**RE: Town of Timmons ville Water Distribution System Improvements
Contract 1
Bid Number 04-17/18
URS Project No. 60487474**

ADDENDUM NO. 2 – August 30, 2017

PRIMARY AND SECONDARY ROAD FLEXIBLE PAVEMENT REPLACEMENT

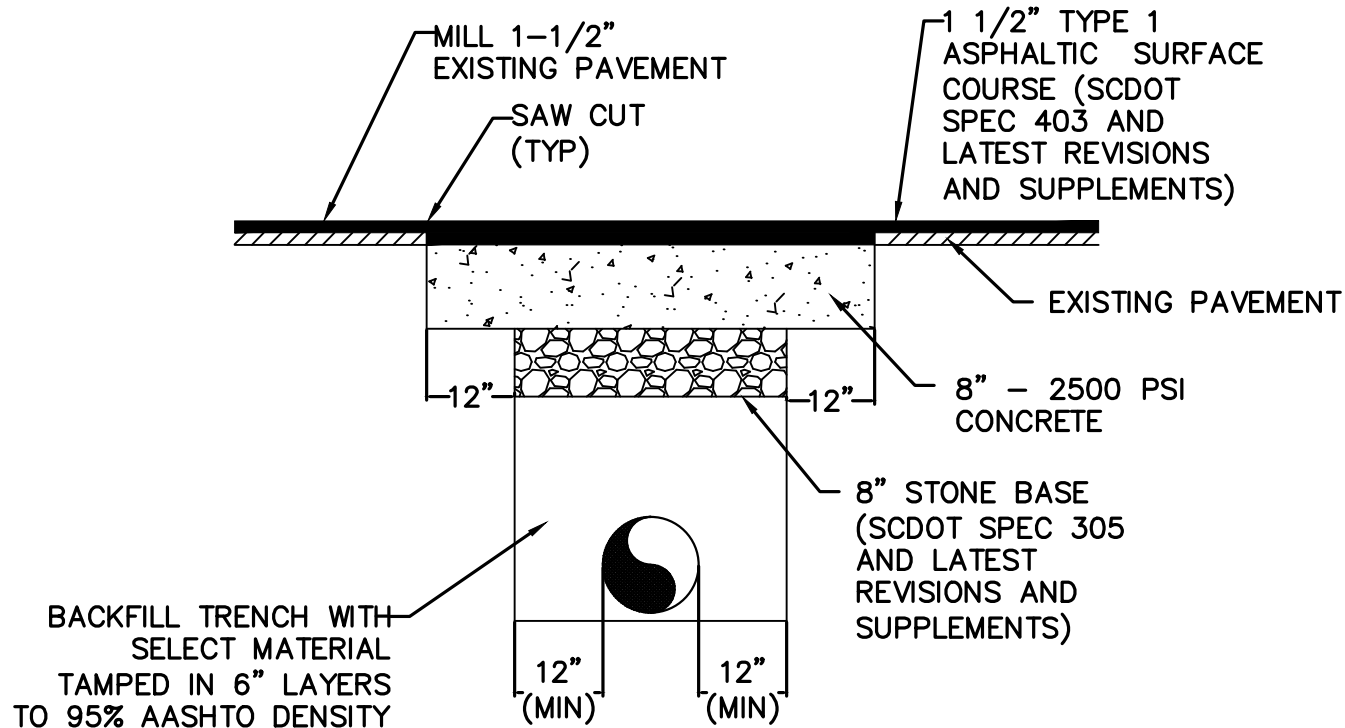
1. DETAIL 7 - SHEET 11

- A. Replace Detail 7 - Primary and Secondary Road Flexible Pavement Replacement with Detail 7 in Exhibit A.
